THE
NATIONAL
BOARD
OF BOILER AND
PRESSURE VESSEL
INSPECTORS

NATIONAL BOARD INSPECTION CODE COMMITTEE

MINUTES

*Meeting of January 22, 2009
Austin, Texas*

Figure S1.4.2 a)

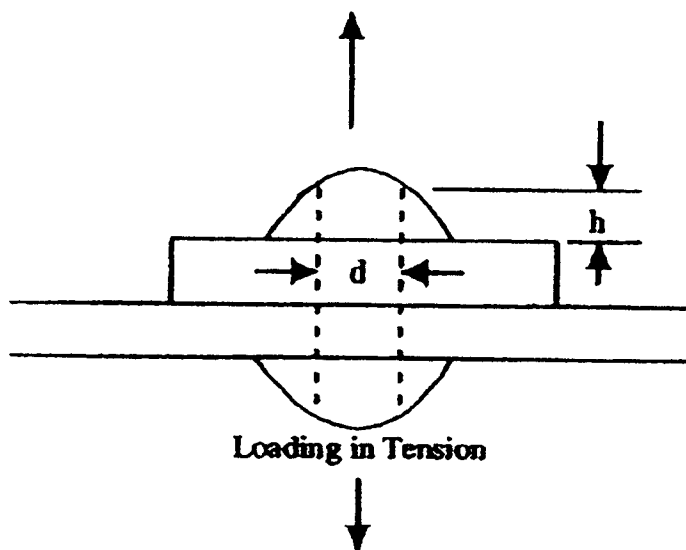
NB07-1006 Part 2, S1.4.2.1 I) SG on Locomotive Boilers The SG on Locomotives recommends adding a new paragraph and sketch illustrating rivet head wastage for rivets in tension.

Mr. Reetz reported with a handout. There was a motion made to accept the sketch and wording as shown. The motion was unanimously approved. (See attachment 2, pg. 2)

FIGURE 3.3.4.2-a

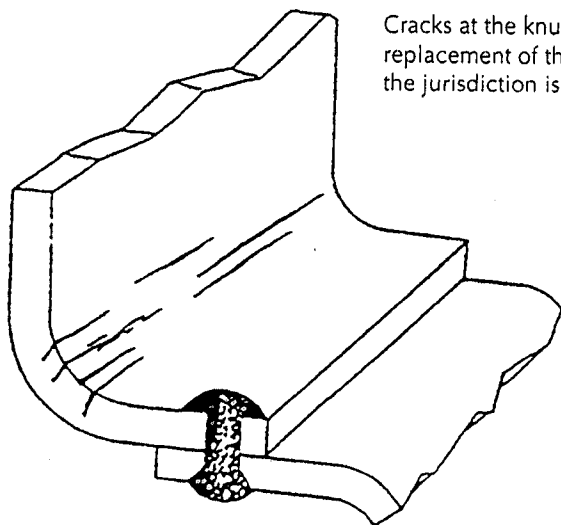
Cracks at the knuckle or at the turn of the flange of the furnace opening require immediate replacement of the affected area or specific approval of repairs by the Jurisdiction. See Figure 3.3.4.2-a.

TABLE 2.5.3

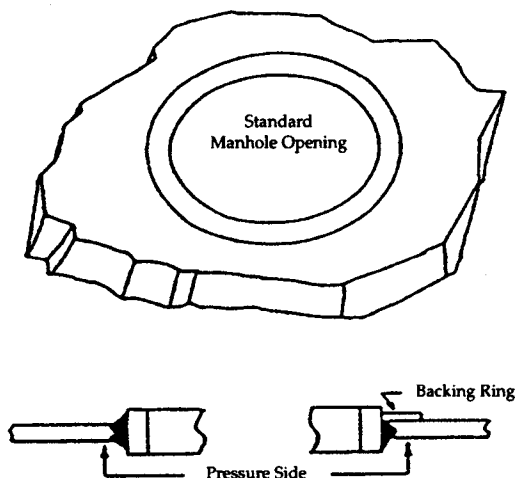
NB09-0401 Part 3 Table 2.5.3 Delete this table and use ASME Section IX TemperBead Procedure Qualification Requirements. This action item is a result of a request received by G. Galanes.

Proposal Request to delete Table 2.5.3 in Part 3 of the 2007 Edition of the NBIC

Explanation The request for deletion of Table 2.5.3 was considered. This table no longer is needed and conflicts with Section IX of the ASME Boiler and Pressure Vessel Code regarding temper bead qualification. This table was originally used for guidance because the temper bead method had not been recognized by ASME B&PV Code.

**FIGURE 3.3.4.3-c****External Overlay Terms and Definitions**

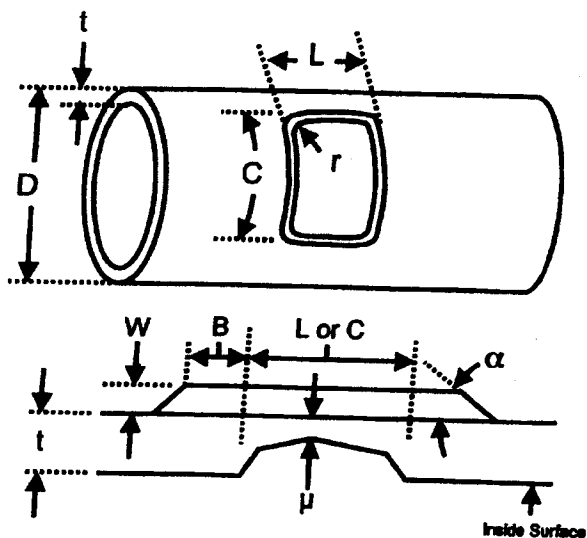
NB09-0701 Part 3 Figure 3.3.4.3 c) Revise wording in sketch demonstrating external weld metal buildup terms to include a definition of "r". This action item is the result of a request received by B. Wielgoszinski.

ADD:
 r = minimum radius, not less than the overlay thickness.
